Re: Hudson Logistics Center - Conditional Use Permit  
Application Supplemental Filing

RE: Hudson Logistics Center - Conditional Use Permit Application  
Supplemental Filing

This letter constitutes Hillwood Enterprises, L.P.'s ("Hillwood") final updated Conditional Use Permit analysis narrative in support of its proposed redevelopment of the Greenmeadow Golf Club into the Hudson Logistics Center (the "Project" or the "HLC"). As we note below, the Planning Board and Conservation Commission review process over the last several months has led to several adjustments to the plans which have further reduced proposed impacts to resources protected under the Town's Wetland Conservation Overlay District (the "District"). This filing also specifically incorporates all documents previously filed by Hillwood or its agents, to specifically include all reports and filings by Langan Engineering and Environmental Services ("Langan") on behalf of Hillwood, Gove Environmental Services, Inc. ("Gove") on behalf of Hillwood, and all filings by Lucas Environmental, LLC ("Lucas") on behalf of Hillwood.

FIGURE 2

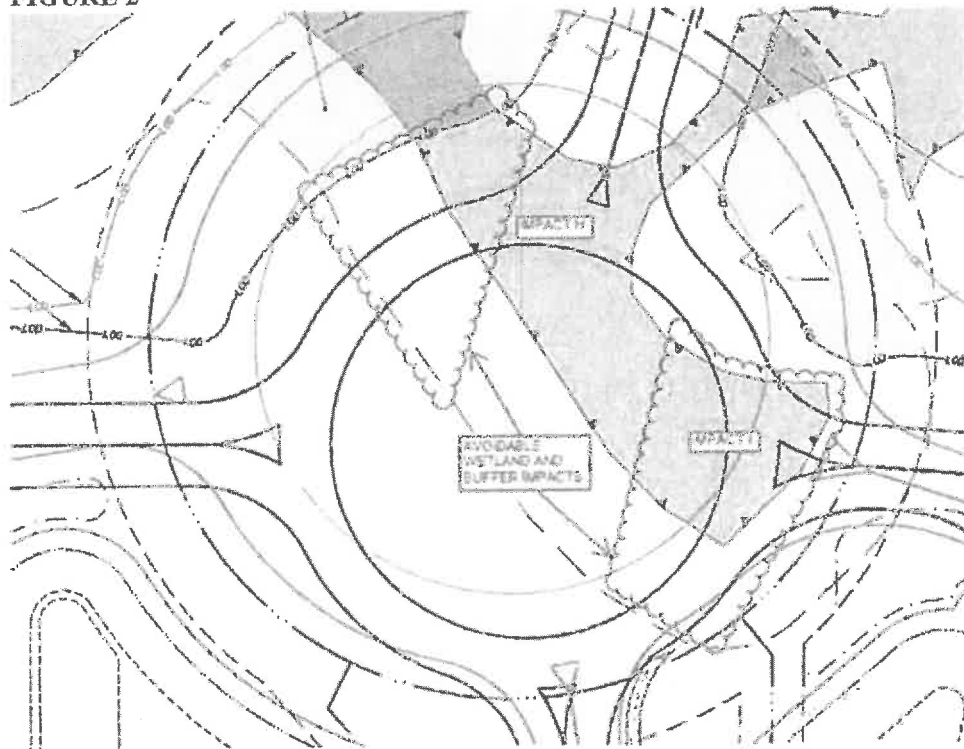
*As currently designed, the access road, Green Meadow Drive, or more specifically the traffic circle, does not avoid and minimize wetland impacts. Below is a discussion of why the current design cannot meet the definition of practicable and thus the avoidance and minimization standard cited above in Env-Wt 313.03. Refer to Figure 2 below. The red clouds identify wetland and buffer zone areas which could easily be avoided if the cul-de-sac were extended a distance that is sufficient to allow the traffic circle to be built outside of wetland jurisdiction. I estimate that distance to be approximately 150 feet. The area between the two red clouds will be impacted regardless of whether the access road is extended.*

**RESPONSE:** See GES Letter, Conditional Use Permit Narrative, cul-de-sac configuration sketches and above analysis.
